Access Compliance Report Public Rights-of-Way (Curb Ramps)

| Intersection ID: N/A | Main Street: ELEANOR_RIGBY_RD | Cross Street: MAGGIE_MAY_LN | Location: NE |
| ADA ID: C98D946FF293 | Ramp Type: Perp | Initial Pass/Fail: Fail | Overall Compliance: No |

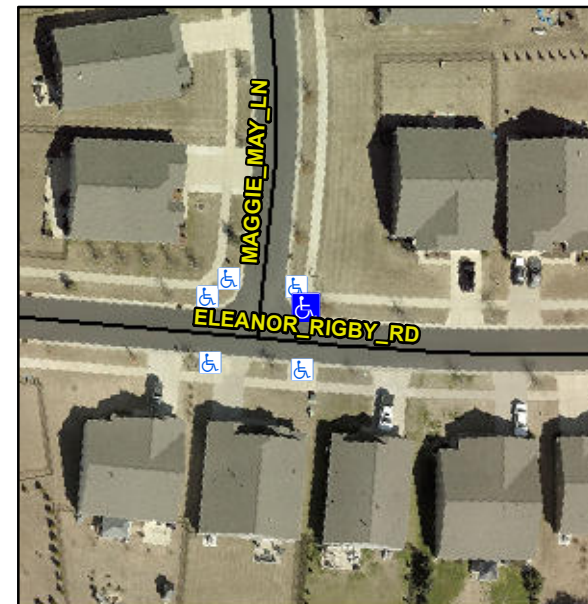
Surveyor Notes:

N/A

PROW/ADA:

Not Found, R304.5.1, R304.5.3

| Compliance | Description | Data | Compliance | Description | Data |
|------------|-----------------------|-------|------------|-----------------------------|------|
| No | Ramp Width (in) | 47.0 | No | Ramp XSlope (%) | 3.2 |

Possible Solutions:

Remove & Replace Entire Ramp.
